# LUXURY HADDAD APARTMENTS 2324 JOHNSON STREET TAC #18-DP-33

### TECHNICAL ADVISORY COMMITTEE REPORT

18-DP-33

Site Plan Review for a 12 unit residential development (Haddad Luxury Apartments).

SHEET NUMBER L-200

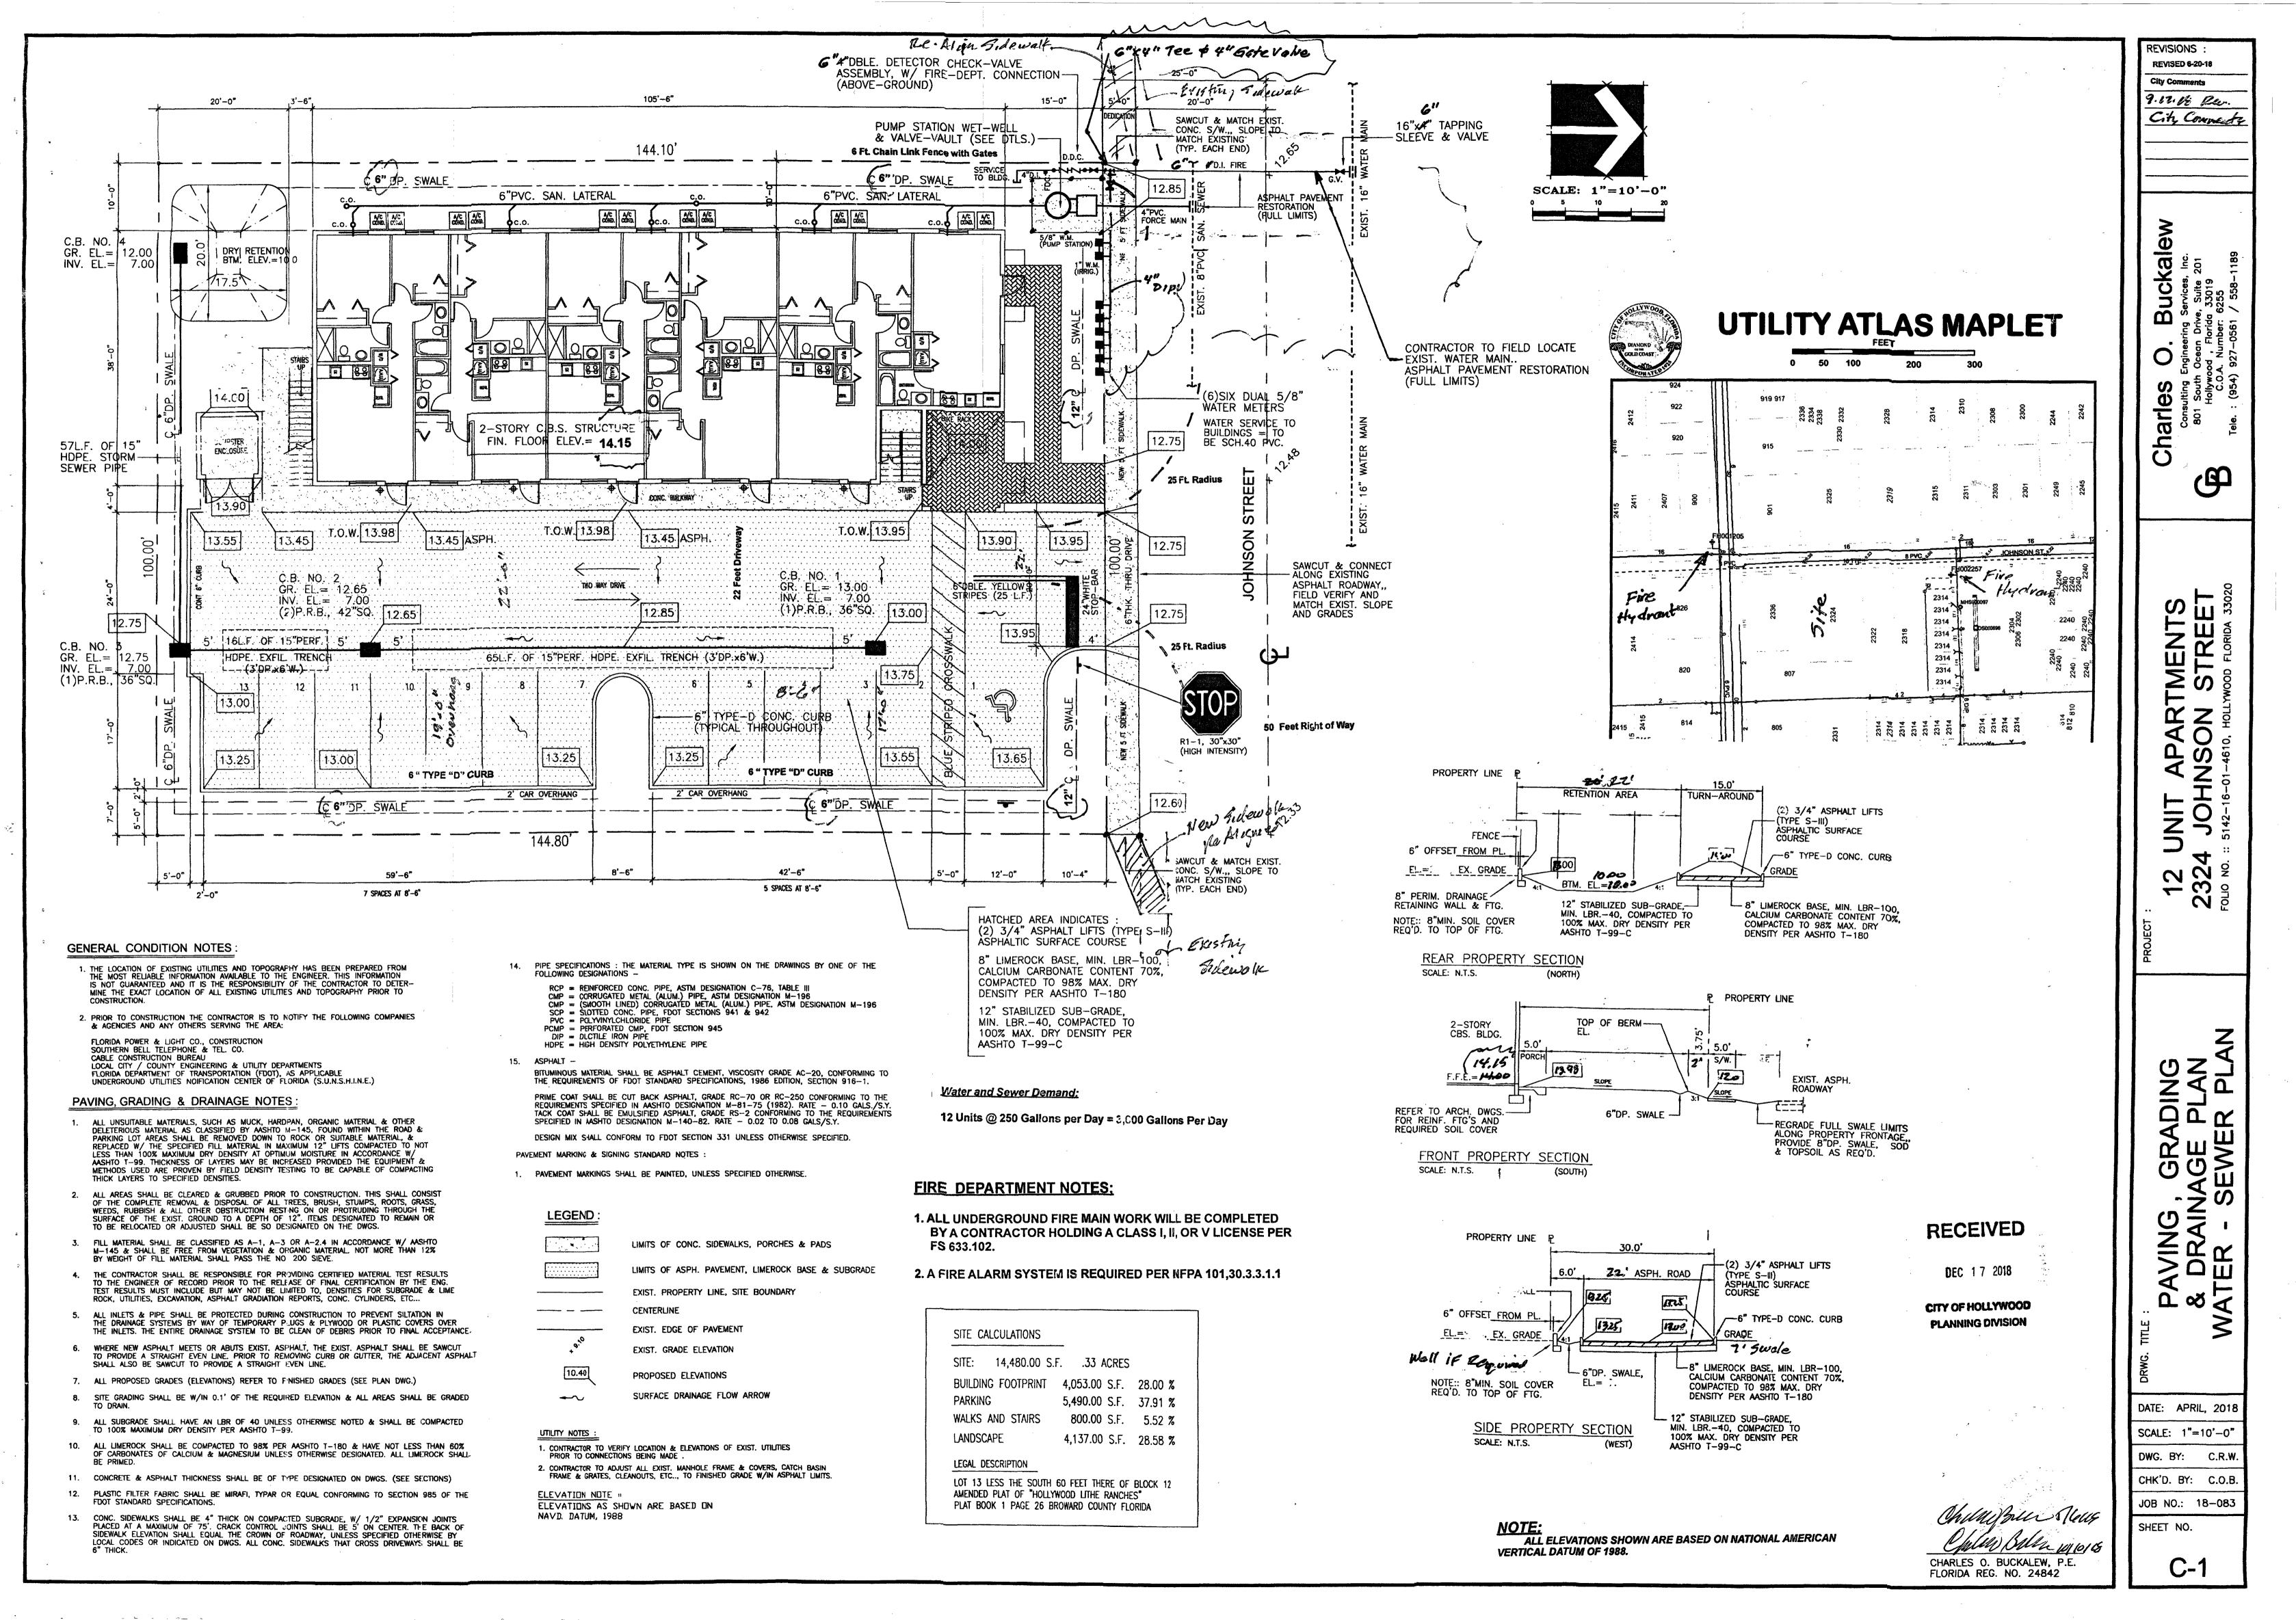
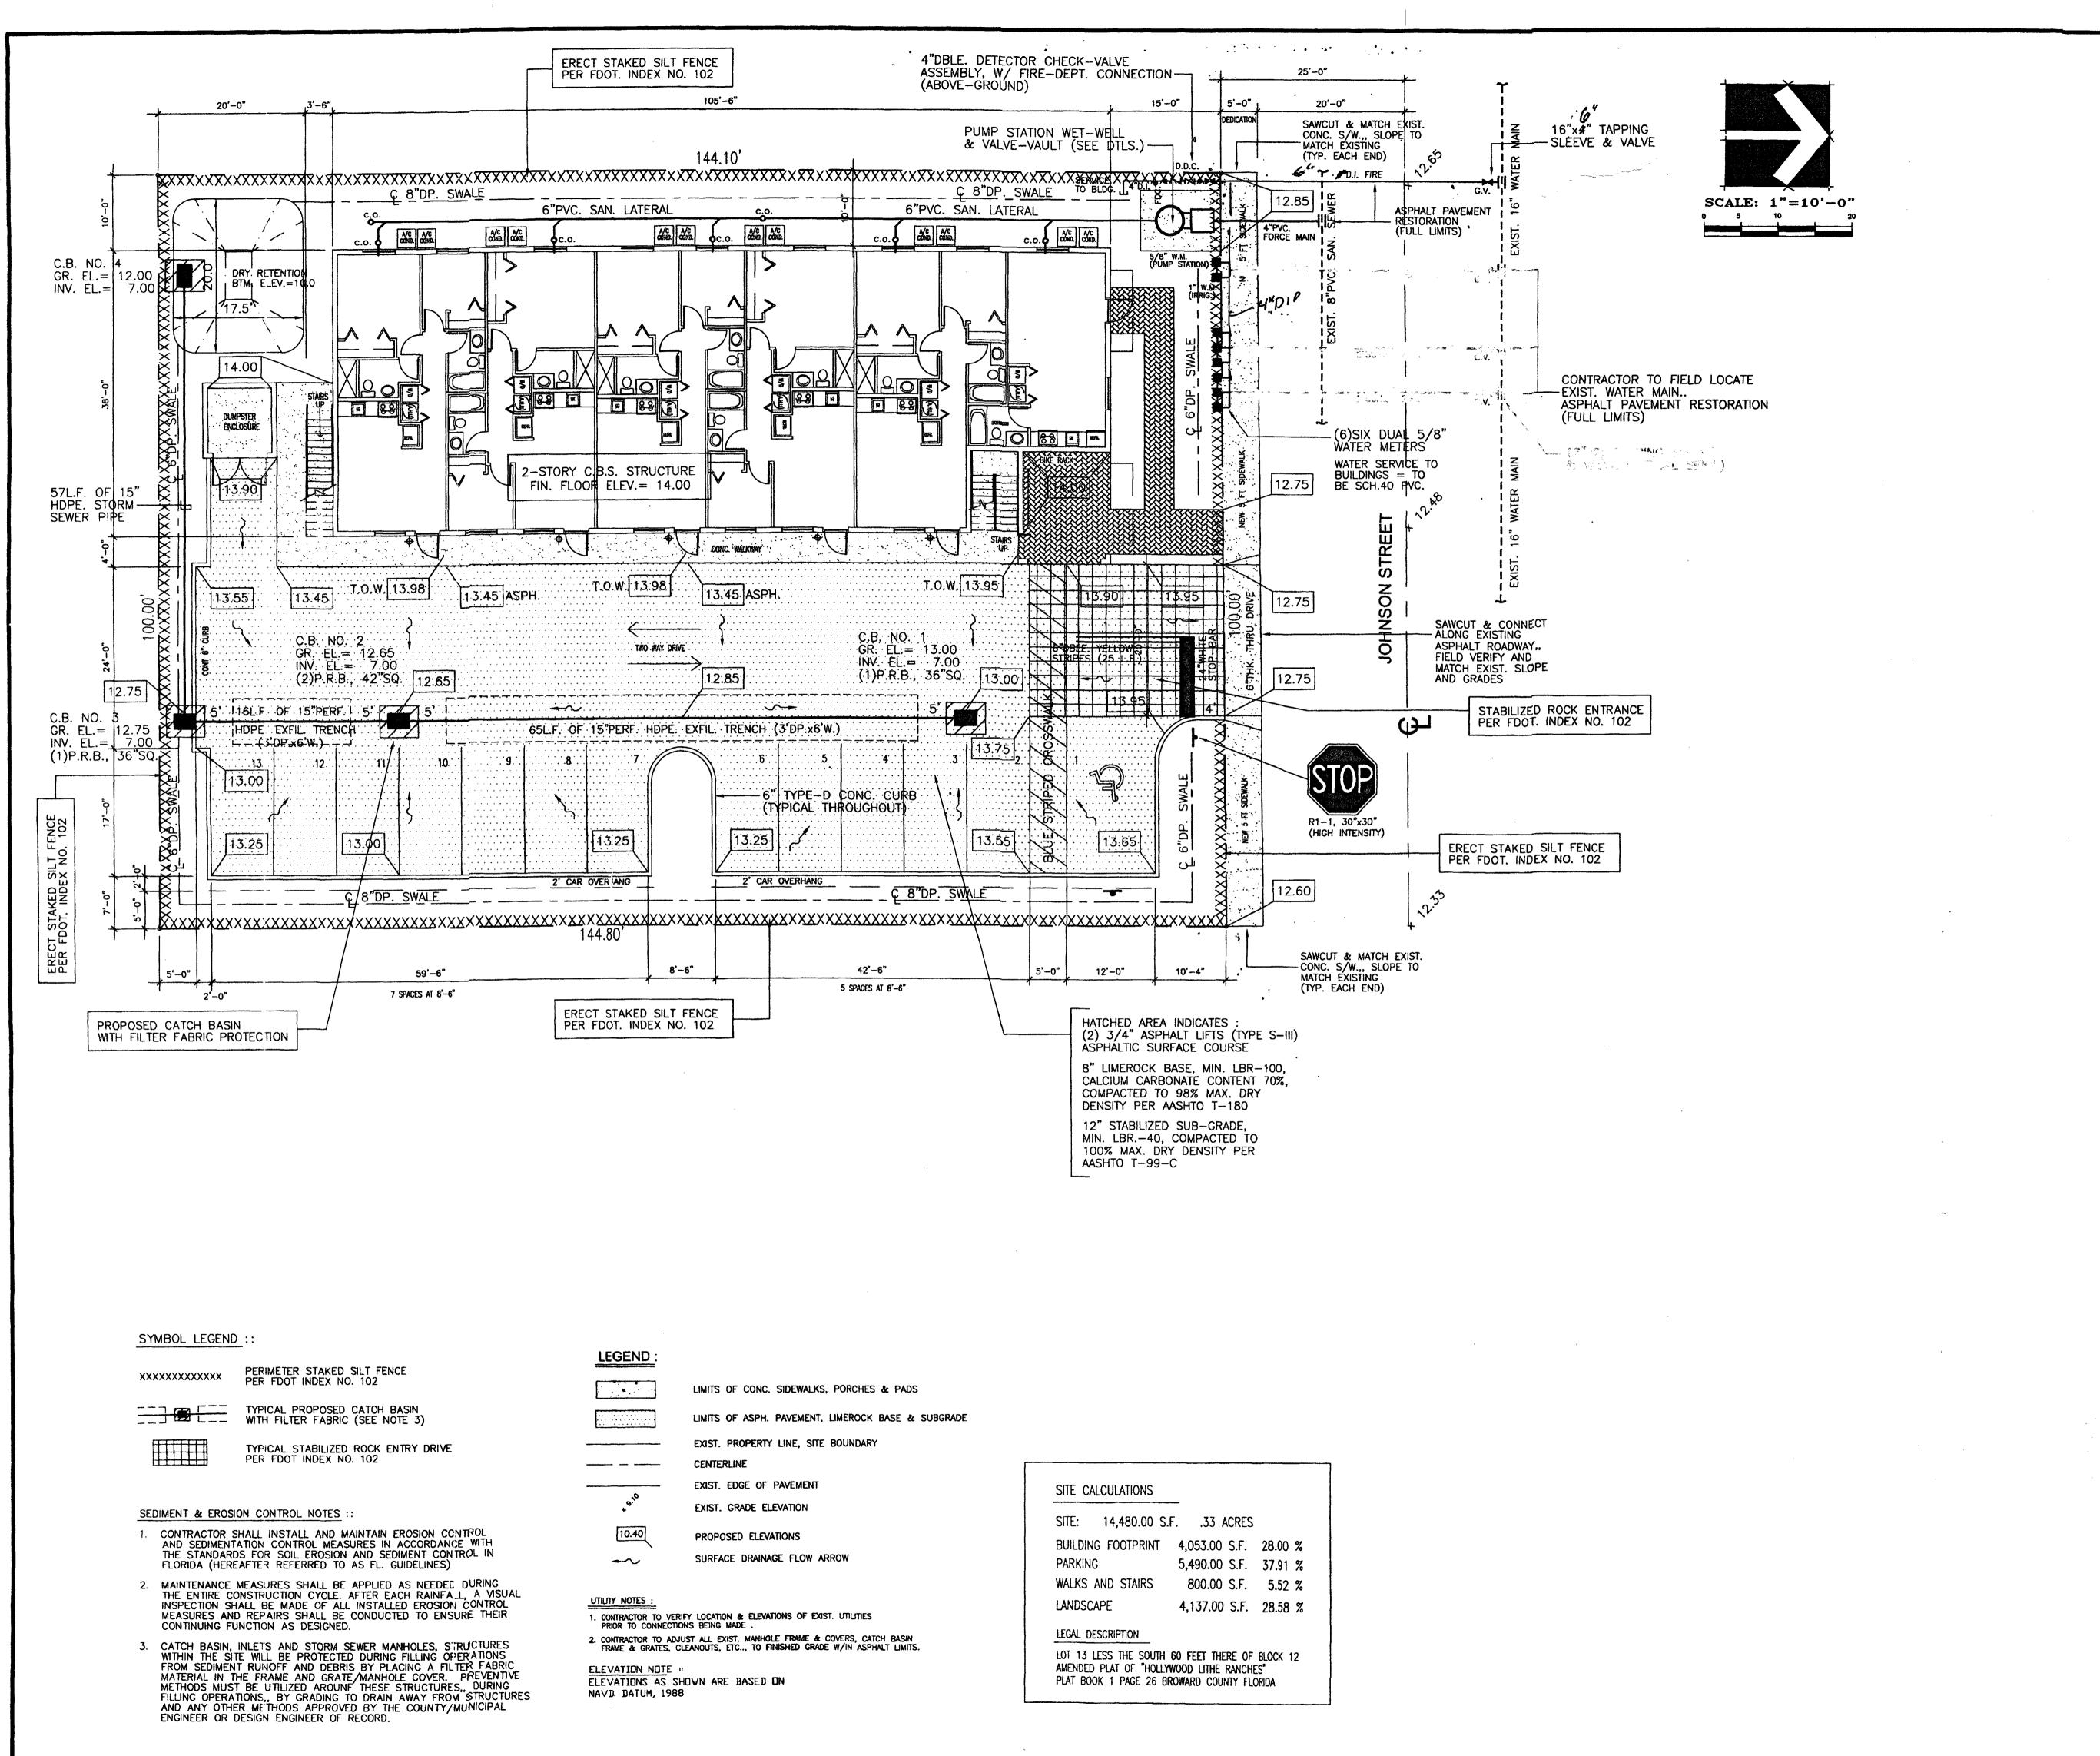
- As per submitted landscape planting plan L-200 please provide further clarification in regard to tree
  mitigation total inches of DBH in lieu of hardwoods and thirty one (31) palm trees removed
- Clarity is still needed to define code required ten (10) trees and separate owed 31 palms and 66" DBH broadleaf tree mitigation please provide a plant list table that clearly defines both with a symbol or within description area of proposed landscape table.

- 8. Landscape architect should coordinate with civil plans to accommodate for drainage swales and retention areas accordingly. Trees are proposed within swales. Furthermore, there appears to be conflict between proposed trees and pipe connecting to catch basin #4.

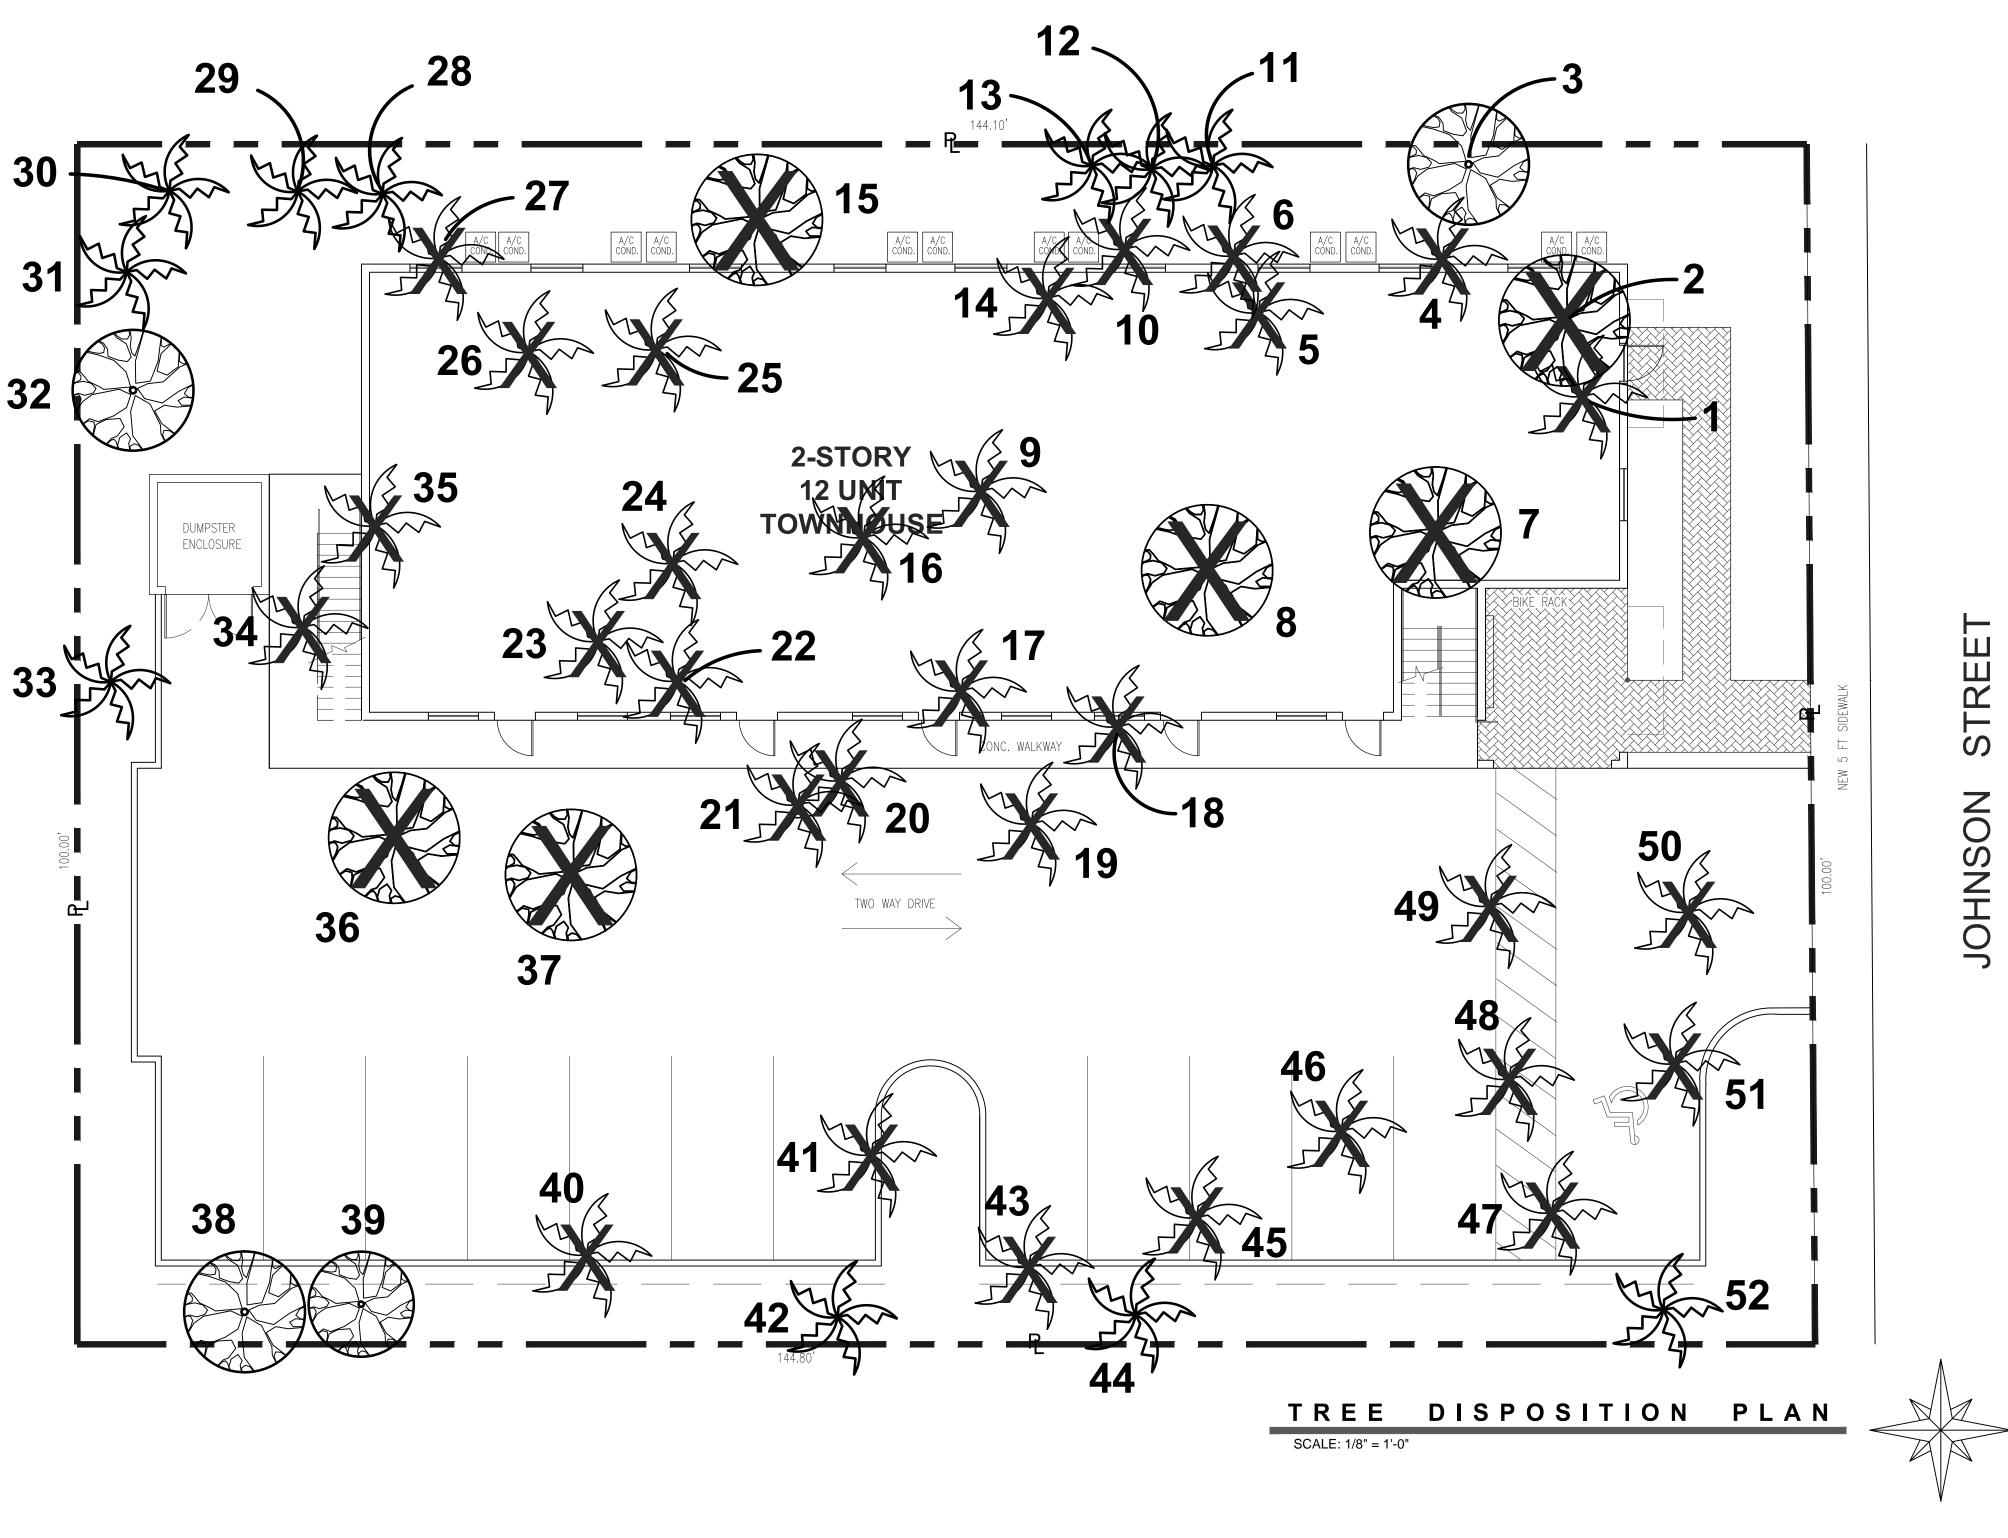
- Provide water and sewer flow demand calculations on Sheet C1. PARTIALLY ADDRESSED. 12 UNITS @ 250 Gals/Unit = 3,000 GPD.
- 5. Revise sections to revise conflict between "6"DP swale" in section versus "8"DP swale" in plan view.

2. Pg. C-1 does not show existing or new fire hydrants as was requested in prior comment #2.
	3. Prior comments #3 and 4 not addressed on the plan.
L.	PUBLIC WORKS Charles Lassiter, Environmental Services Supervisor (classiter@hollywoodfl.org) 954-967-4207
